HISTORIC AND DESIGN REVIEW COMMISSION

HDRC CASE NO: 2015-234
ADDRESS: 1902 SAN PEDRO AVE
LEGAL DESCRIPTION: NCB 1858 BLK 1 LOT 12 AND 13
ZONING: C2 H
CITY COUNCIL DIST.: 1
DISTRICT: Monte Vista Historic District
APPLICANT: Marcus Guerra
OWNER: Goen Otha Morris
TYPE OF WORK: Exterior alterations
REQUEST:

CIRCA BUILDING
REMODELING/ FINISH OUT
1902 SAN PEDRO AVE.
SAN ANTONIO, TX

DRAWING TITLE
EXTERIOR ELEVATIONS
NEW WORK

2 NEW SIDE ELEVATION
SCALE 3/8" = 1'-0"

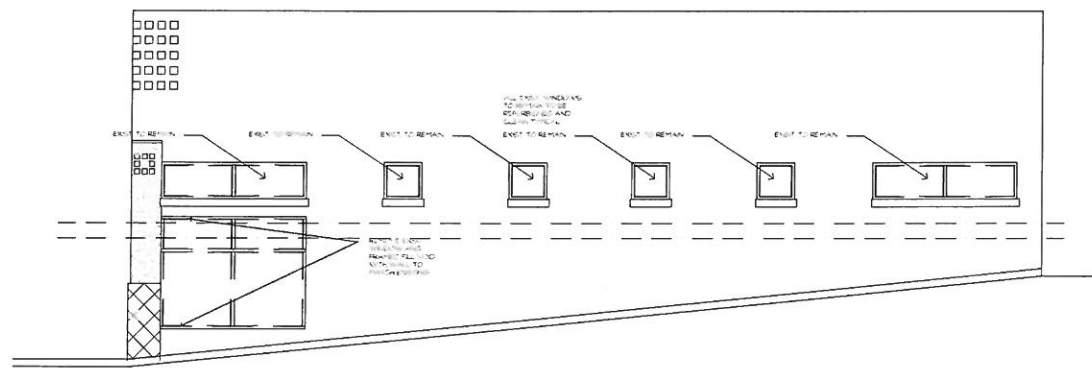
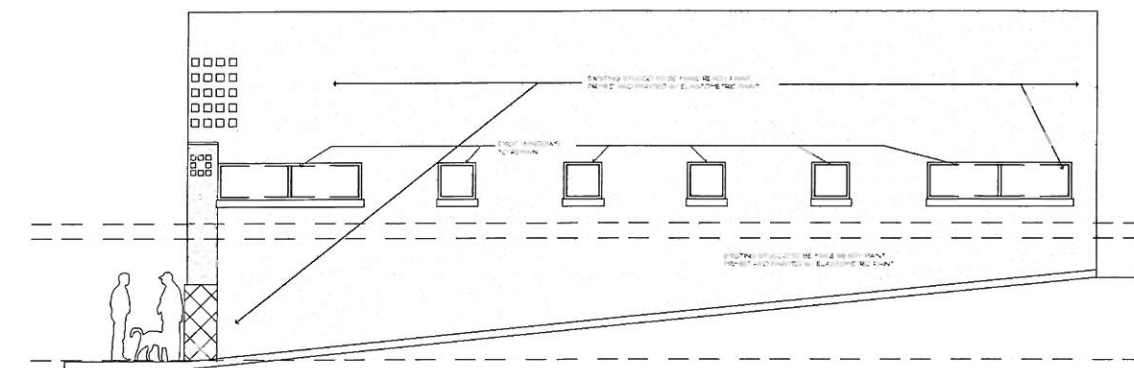
- d. Consistent with the Guidelines for Exterior Maintenance and Alterations, filling in historic window or door openings should be avoided. The proposed infill of the existing windows should be avoided.

way it is. tile - not salvageable, chipped a too much paint.
TC - can you determine type of tile? MG - Yes, we'll go back
to it as close as possible. BF - so only one window is
being removed? MG - Yes, it keeps getting broken. TC - proper
solution for infill. MG - inset stucco to show original opening
TC - new doors dramatically changed proportions. MG -
require push bars inside. TC - if you want the canopy, look
for historic photos. Look for evidence on hardware. MG -
would be ok w/ partial canopy BF - WAK if he can't afford to put
it back completely I wouldn't recommend it.

- 1. Staff recommends approval of item 1 as submitted based on findings a-b.
- 2. Staff does not recommend approval based on finding c.

1 NEW FRONT ELEVATION
SCALE 1/4" = 1'-0"

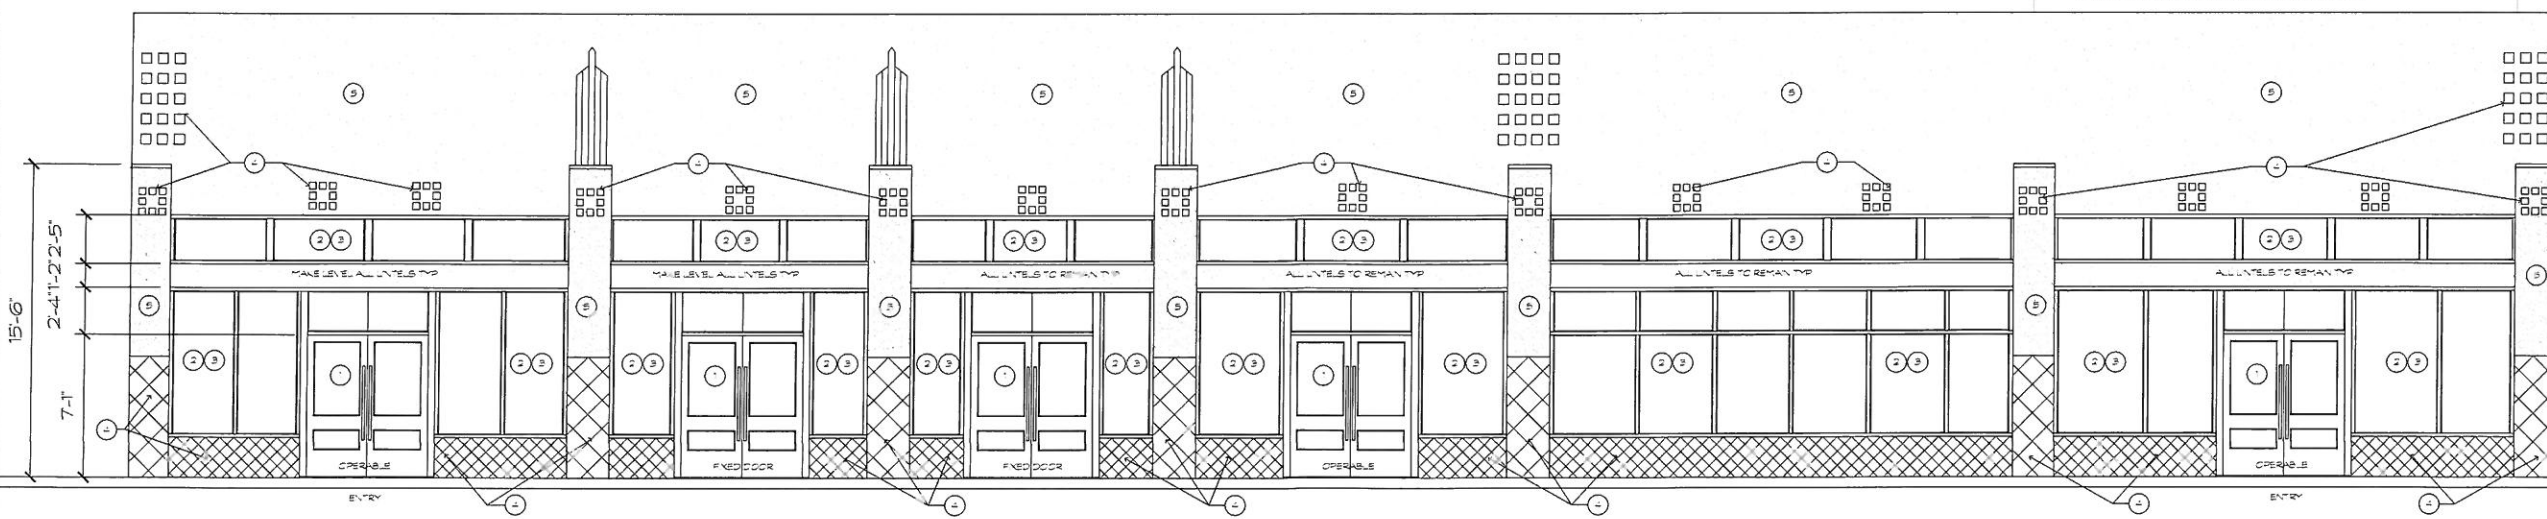
- c. Consistent with the Guidelines for Exterior Maintenance and Alterations, historic doors should be repaired if possible. When deteriorated beyond repair, doors should be replaced in kind to match existing. Although the existing doors appear to be original, the proposed replacement doors will allow for placement of interior push bars which are required for emergency egress.
